Service Letter No. EX7 October, 1995

Subject: Changes to 110 mm Extarder™ Models

Models Affected: EXC83 and EX3116

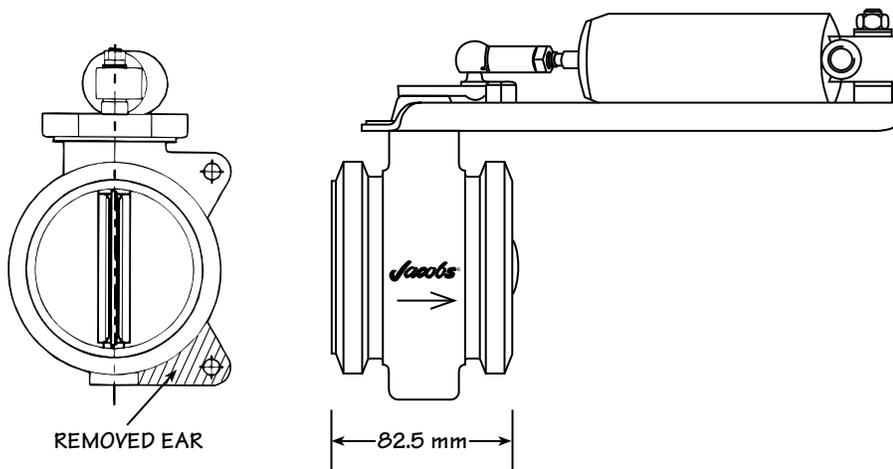
Two changes have been made to all 110 mm brake housings for the Jacobs Extarder. The housing length has reduced from 92 mm to 82.5 mm. Also, the second ear has been removed from the housing assembly. These changes do not affect operation or performance in any way. They are strictly a design change due to manufacturing process upgrades. The size of the butterfly has not changed.
